1434-1444  
 521 5th AVENUE STREET

# CITY OF PORTLAND, MAINE

AP 533-534 Westbrook St.-1

Subject: Application for permit for  
new dwelling at 534-544 Westbrook  
Street.

PROPOSED INSTALLATION OF 500 GAL  
BULK TANK UNDERGROUND AT  
RESIDENCE OF

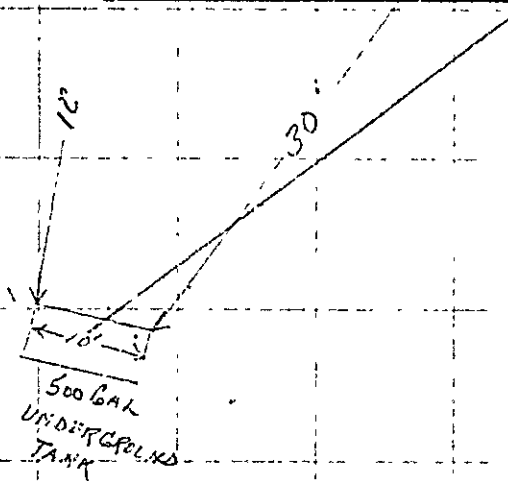
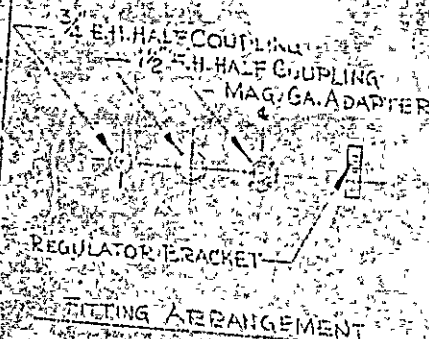
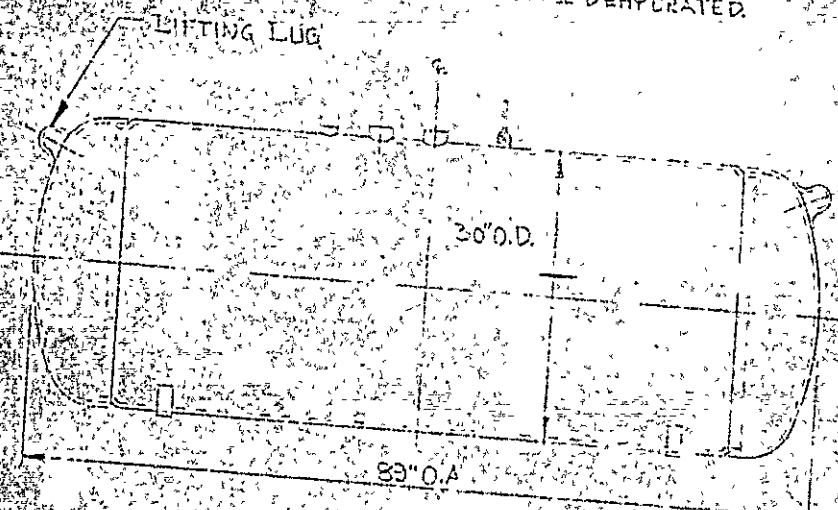
Permit for installation of an underground tank for bulk storage of liquefied petroleum gas on the premises at the above named location is issued herewith subject to the condition that the installation is to comply in all respects with requirements of Pamphlet #59 of the National Fire Protection Association and in addition with any special requirements of the Fire Department. As is the case with underground tanks for the storage of inflammable liquids, the tank is not to be covered until after inspection and approval by a representative of the Fire Department.

Location of tank is such to  
prevent damage from residential  
traffic. 10' clearance  
retained from buildings or property  
lines  
Proposed installation is complete  
in all respects with requirements  
as set forth in 7.11 P.Q. #58

DONALD LANG

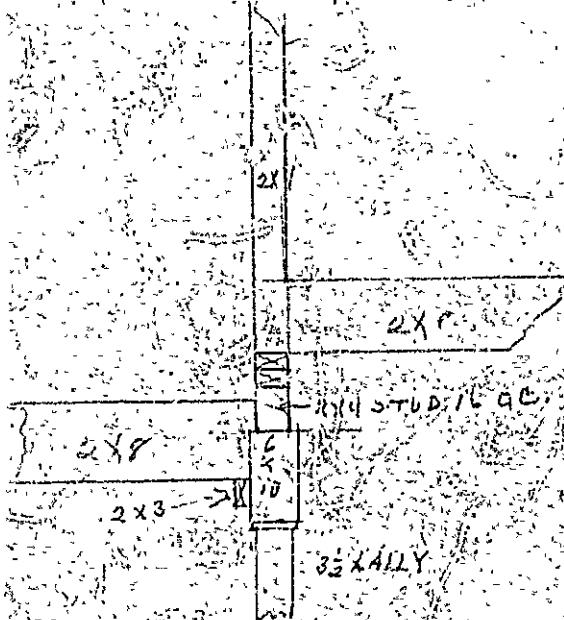
1. The 6x8 dressed hemlock girders indicated on plan and in application are not large enough on the spans shown of about 8' to take care of the theoretical loads that may come upon them. Either an 8x8 or a 6x10 dressed hemlock timber would satisfy the requirements. - O.K.

2. Presumably foundations similar to those of garage are to be provided for the breezeway. What is the size of timbers to be used to support outer ends of rafters of this structure? - O.K.

3. How are the front and rear walls to be tied at the plate line since the second floor joists run parallel to those walls? - O.K.
4. What is size of headers across openings for bay windows? - O.K.

5. What construction is to be followed on girder that supports the sunken floor of livingroom and that of hall at a higher level? Some method should be used, if possible, that will not provide unequal shrinkage on either side of this girder. - O.K.

#1  
GULFERS 6x10

#2 BREZWAY  
WILL SAME AS  
GARAGE  
4x6 PLATE

#3 3x2 RDN STRAP  
BELTED TO UNDGR  
SIDE OF 2 FLOOR  
TIMBERS AND  
HOOKS ROUN ON  
PLATE 1/2" O.C.

#4  
4x4 HEADER
